Document Identification: *Explanation of Significant Differences to
the Record of Decision for the Interim Remedial Action of
the Northeast Plume at the Paducah Gaseous Diffusion
Plant, Paducah, Kentucky, DOE/LX/07-1291&D2/R2*

TRANSMITTAL OF THE EXPLANATION OF SIGNIFICANT DIFFERENCES TO THE RECORD OF DECISION FOR THE INTERIM REMEDIAL ACTION OF THE NORTHEAST PLUME AT THE PADUCAH GASEOUS DIFFUSION PLANT, PADUCAH, KENTUCKY, DOE/LX/07-1291&D2/R2

**Explanation of Significant Differences
to the Record of Decision for the Interim Remedial Action
of the Northeast Plume at the
Paducah Gaseous Diffusion Plant
Paducah, Kentucky**

Figure 4. TCE in the Regional Gravel Aquifer in the Vicinity of PGDP (2014)

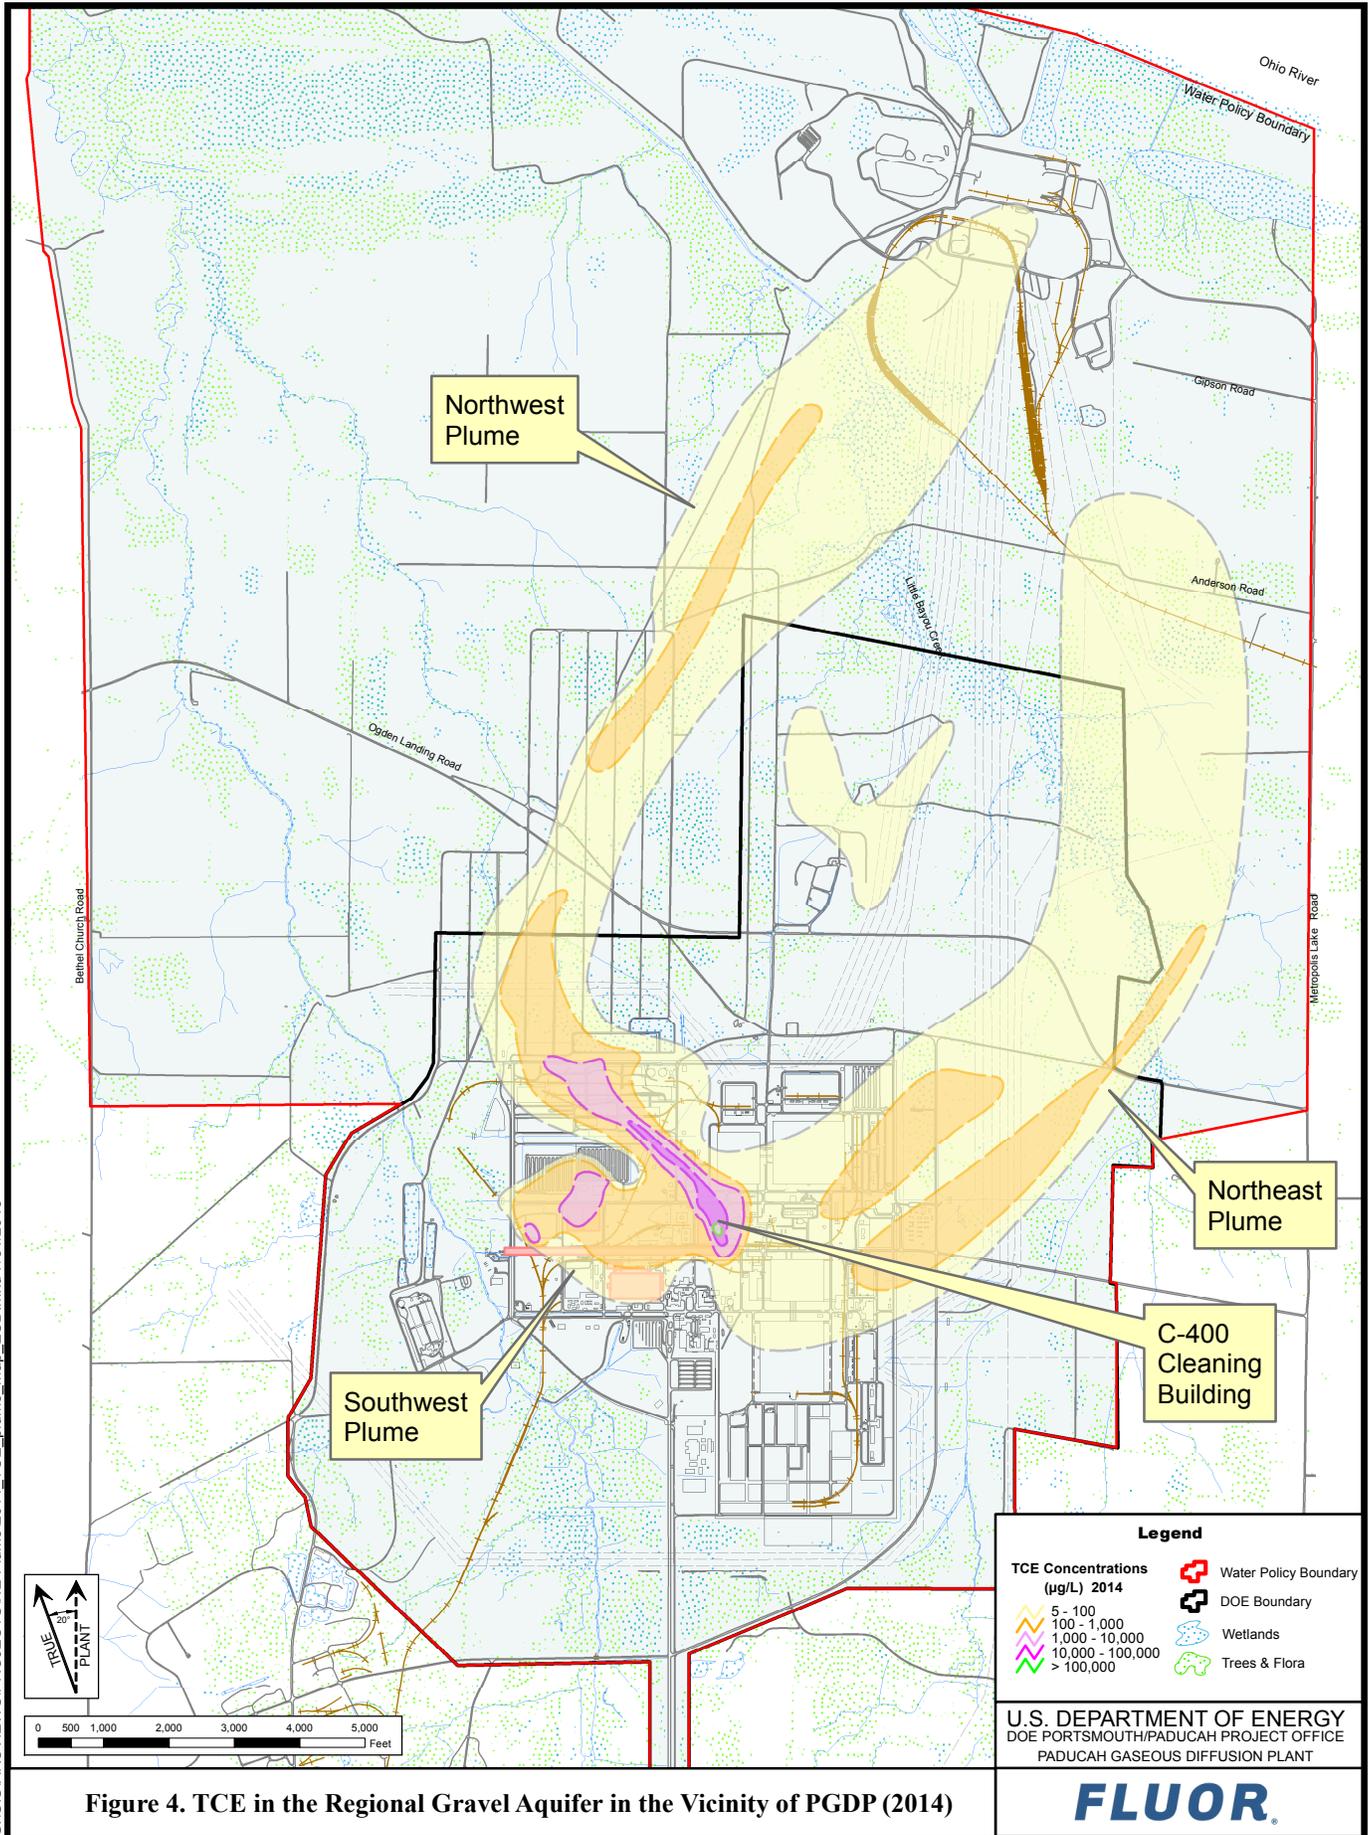
Use update and revised figure.

Figure 5. Locations of New and Preexisting EWs Associated with the Northeast Plume IRA at PGDP

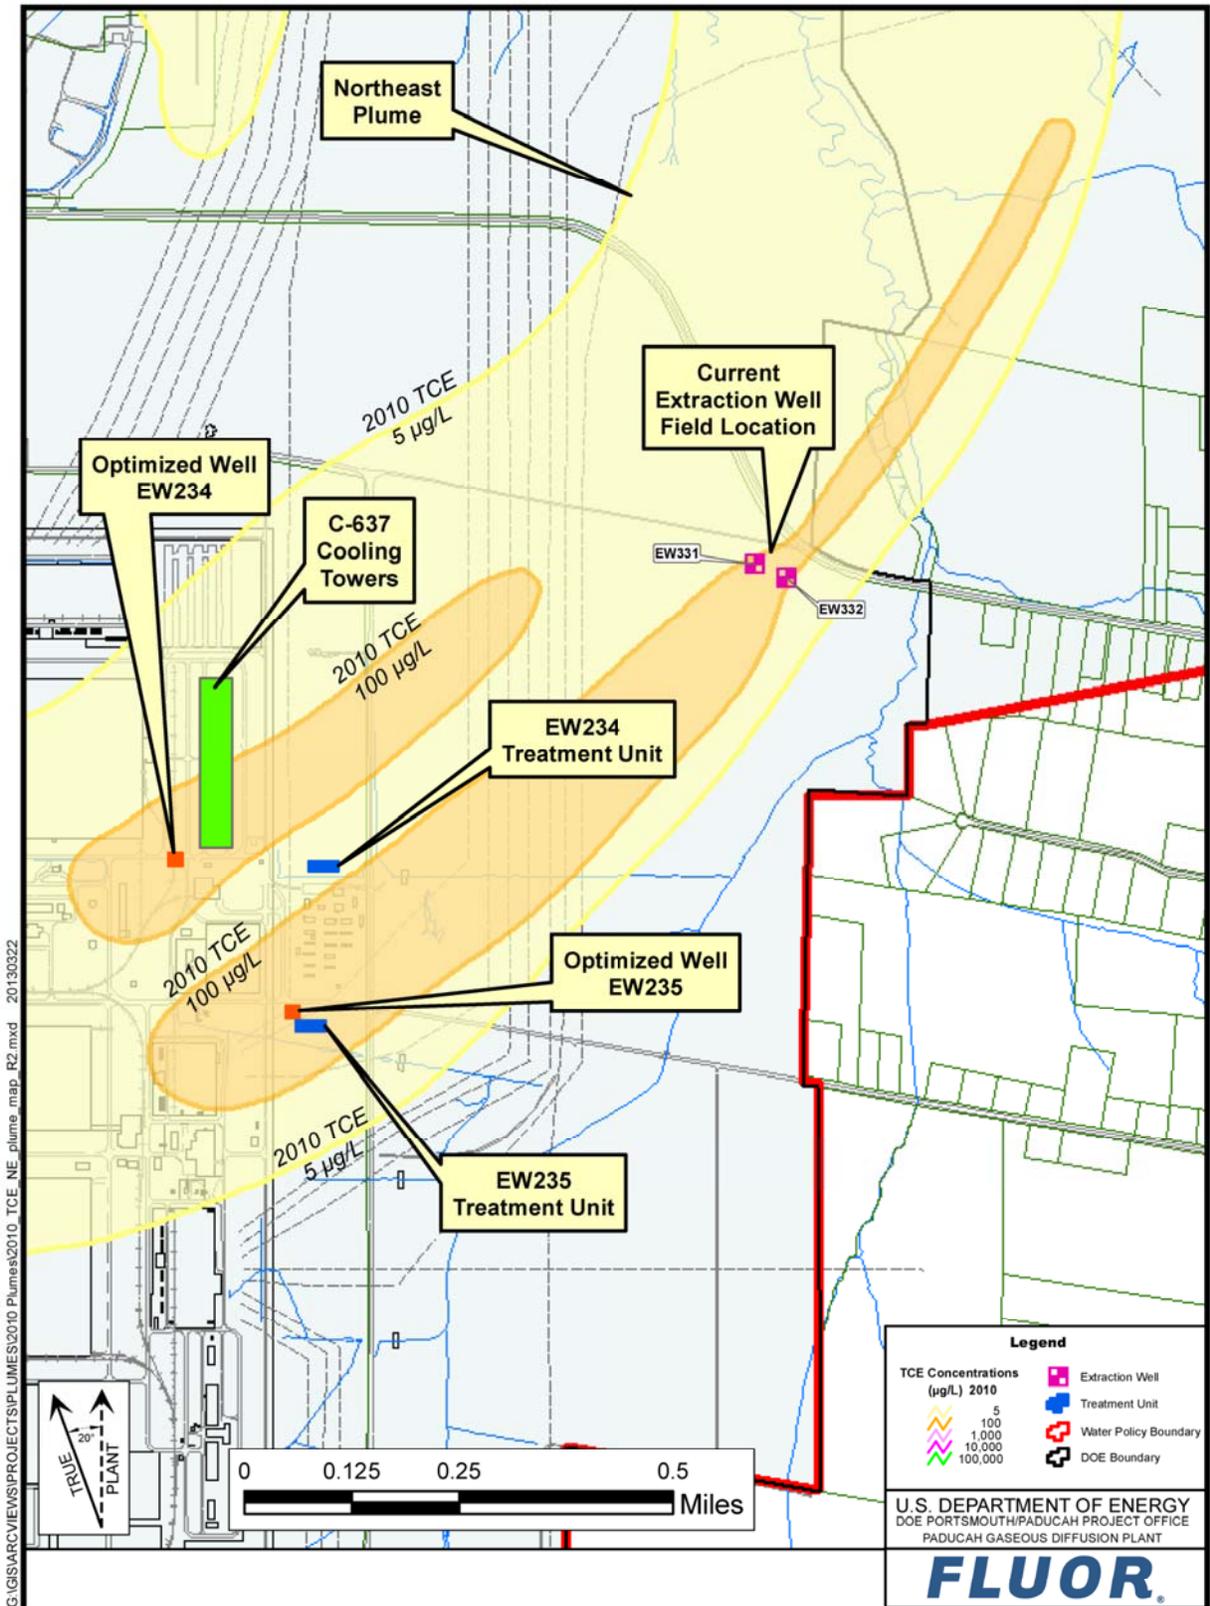
- Replace the two existing EWs (EW331 and EW332) with two new groundwater EWs (EW234 and EW235) to be in the upgradient high concentration portion of the Northeast Plume and near the eastern edge of the PGDP industrial facility (approximately 300 gal per minute combined extraction rate).

Well field optimization modeling indicates that a two-well configuration is optimal. The two new wells, EW234 and EW235 are to be located near the eastern edge of the PGDP facility. Refer to Figure 5 for well locations. The EWs (EW234 and EW235) are expected to have an operational flow rate of approximately 150 gpm each. Detailed lithologic logs and grain size analysis to the extent available will be used in well screen and filter pack design of the new EWs (EW234 and EW235). Once the two optimized EWs are online, contaminant concentrations in samples from the transect wells will be collected on a quarterly basis and reported to EPA and KDEP. If contaminant concentrations in any transect well's quarterly samples are determined to be increasing and may double above the established baseline within a year of the quarterly samples' showing an increase, then potential changes in groundwater flow or source impacts (e.g., rising contaminant concentrations in the Northeast Plume, source migration, etc.) will be examined further. The FFA parties will consider adjustments (e.g., adjusting EW pumping rates) for the optimized Northeast Plume interim action to minimize these potential impacts. These adjustments are considered within the scope of the optimization under the ESD.
